Canadian Standards Association
Etobicoke, Ontario
To the Part I Committee

Subject No. 3049

Title: Emergency Shutoff Switch, Rule 68-404(d)

Exhibit 680.17 Location of the emergency shutoff device required by 680.41.

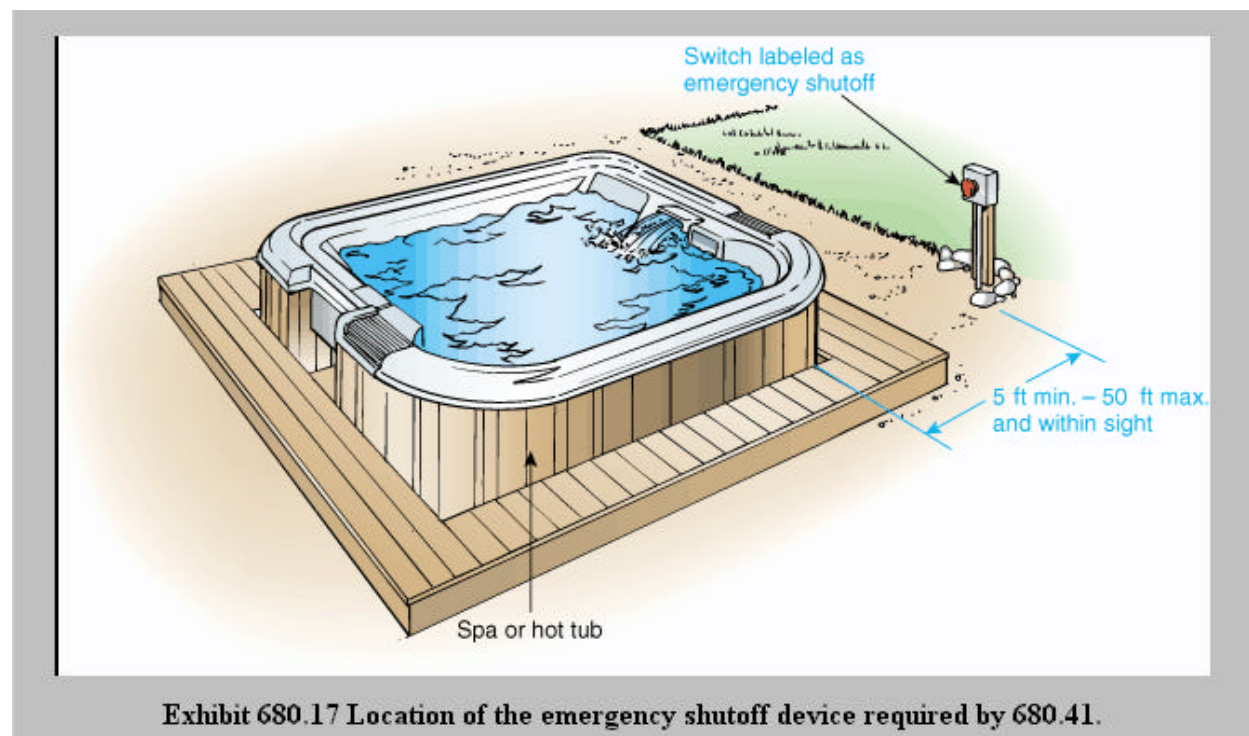
- 3) Should distance from the hot tub be limited to 10 M?
- 4) I'm not disagreeing with the intent of the proposal. However, I think it needs some improvements. First of all, it could include explanation why it does not apply to "single family dwellings". Is the safety problem not the same wherever "SPA or HOT TUB" are installed? As well, why is the proposal dealing with "1.5M" and the actual Subrule (1) dealing with "1M"? Is there anything more or less dangerous between "Controls" and "Emergency Shutoff Switch"? Could we be consistent with the CEC and forget about the NEC? Finally, the proposed drawing for the "Handbook" shall be in accordance with the CEC (right "Rule Number" for the title of the drawing and use "Metric Units").

Exhibit 680.17 Location of the emergency shutoff device required by 680.41.

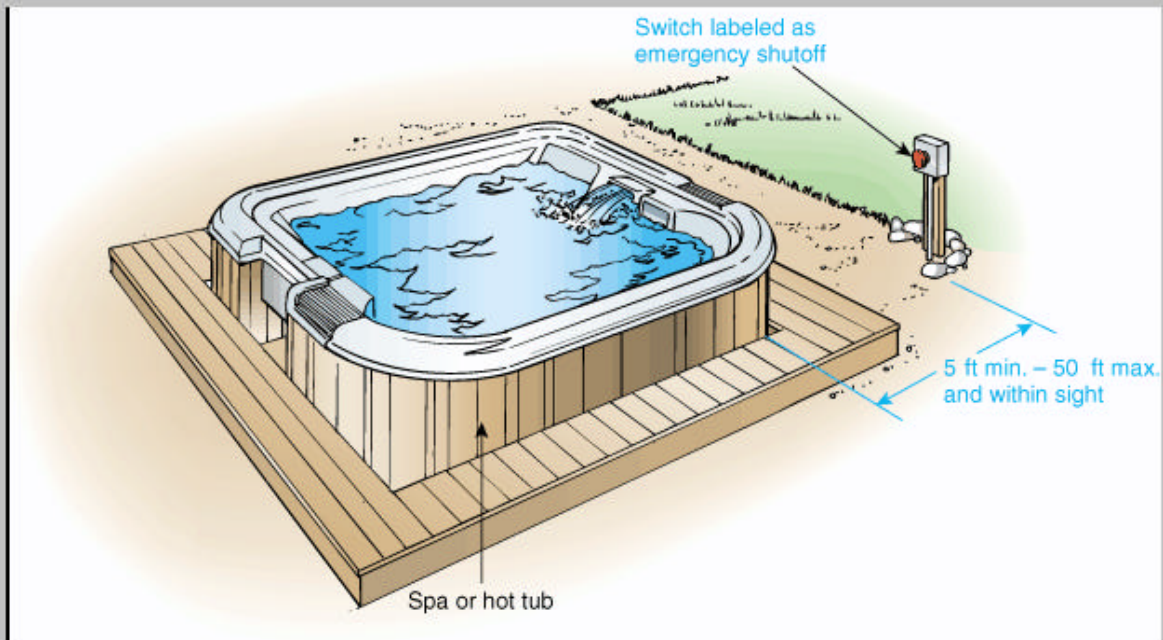
Add the following drawing to the CEC Handbook for Rule 68-404 (4) with the following modifications:

1. Change the rule reference from 680.17 and 680.41 to Rule 68-404 (4)
2. Change the measurement wording from "5 ft min. - 50ft max. and within sight" to "1 m minimum and within sight"
